Access Compliance Report

Public Rights-of-Way

Intersection ID: 42506	Main Street: CHASEWATER_DR	Cross Street: DARBY_CHASE_DR	Location: SE
ADA ID: 55FAA7BE2EBB	Ramp Type: Perp	Initial Pass/Fail: Fail	Overall Compliance: No
			Severity Score: 18.75

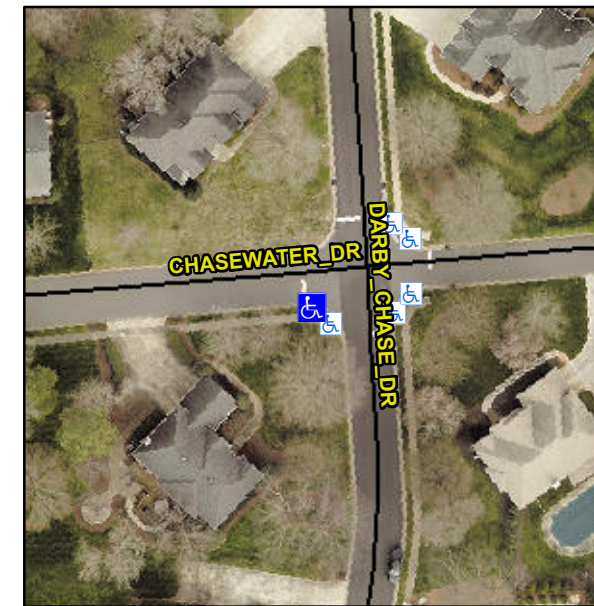
Not Found, R304.5.1, R304.5.3

Compliance	Description	Data	Compliance	Description	Data
N/A	Ramp Length (in)	48.0	Yes	Ramp Slope (%)	6.1
No	Ramp Width (in)	35.0	No	Ramp XSlope (%)	2.8
N/A	Flare Type LT	N/A	N/A	Flare Type RT	N/A
N/A	Flare Slope LT (%)	N/A	N/A	Flare Slope RT (%)	N/A
N/A	Flare Traversable LT?	N/A	N/A	Flare Traversable RT?	N/A
N/A	Landing Length (in)	N/A	N/A	DWS Provided?	N/A
N/A	Landing Width (in)	N/A	N/A	DWS Contrast?	N/A
N/A	Landing Slope (%)	N/A	N/A	DWS Length (in)	N/A
N/A	Landing X Slope (%)	N/A	N/A	DWS Full Width?	N/A
N/A	Landing Curb? (Y/N)	N/A	N/A	DWS Offset (in)	N/A
N/A	Shared Landing?	N/A			
N/A	Gutter Ponding?	N/A	N/A	Gutter Slope (%)	N/A
N/A	Gutter Lip Ht (in)	N/A	N/A	Gutter X Slope (%)	N/A
N/A	Painted X Walk1?	No	N/A	Painted X Walk2?	N/A
	X Walk 1 Direction	To N		X Walk 2 Direction	N/A
N/A	X Walk 1 Width (in)	N/A	N/A	X Walk 2 Width (in)	N/A
	X Walk 1 Slope (%)	1.6		X Walk 2 Slope (%)	N/A
	X Walk 1 X Slope (%)	4.2		X Walk 2 X Slope (%)	N/A

Remove & Replace Entire Ramp.
